Addendum #1

**Traffic Signal Poles at 126th & Highway 370 Intersection
Project, C-77 (10-11)**

**For the
Sarpy County Highway Department**

OLSSON ASSOCIATES
2111 South 47th Street, Suite 200
Omaha, NE 68105
PROJECT NO. 009-1287
SHEET NO. CS-07

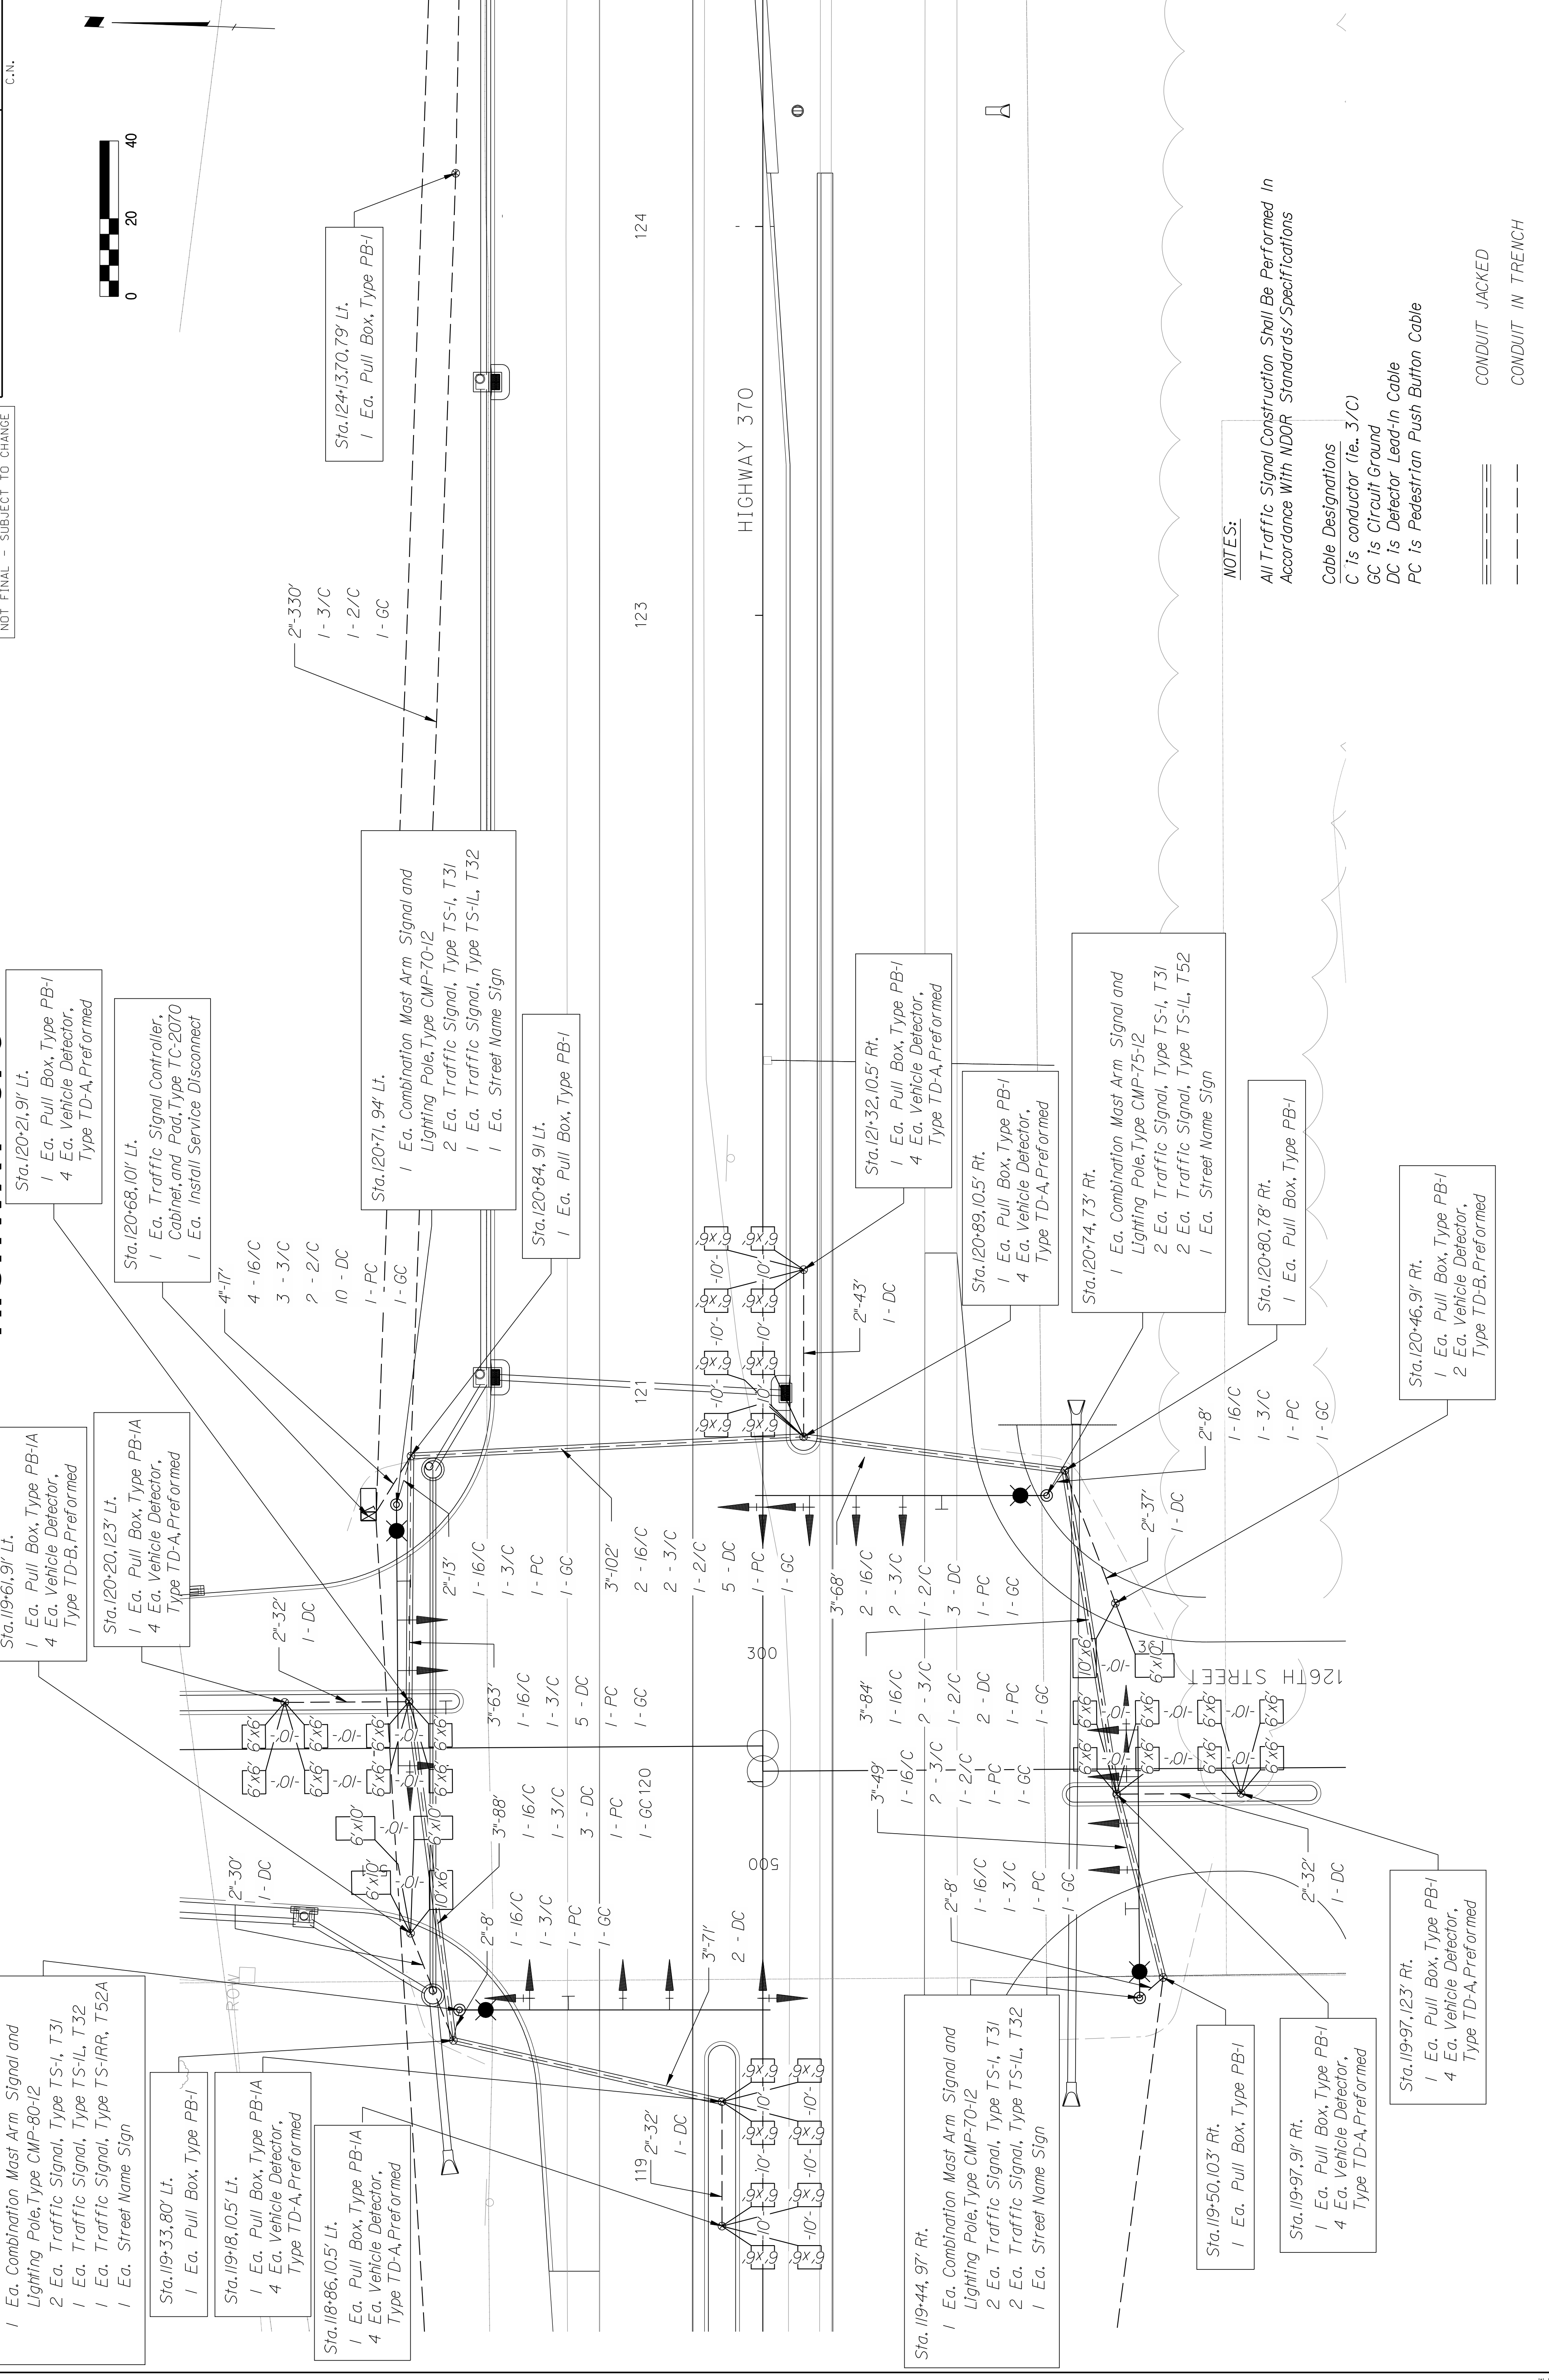
Question 1: What are the loadings for these poles?

Response: *Attached is a DRAFT plan (which is subject to change by NDOR) for 126 & Highway 370. To account for additional heads and future six (6) lane section and the additional dual left turn lanes for the WBL and NBL (1 TS-1 for each of the EB and WB through directions/1-TS-1L for each of the tern lanes). An item that is not requested, but may be added in the future is opticom, which should be accounted for.*
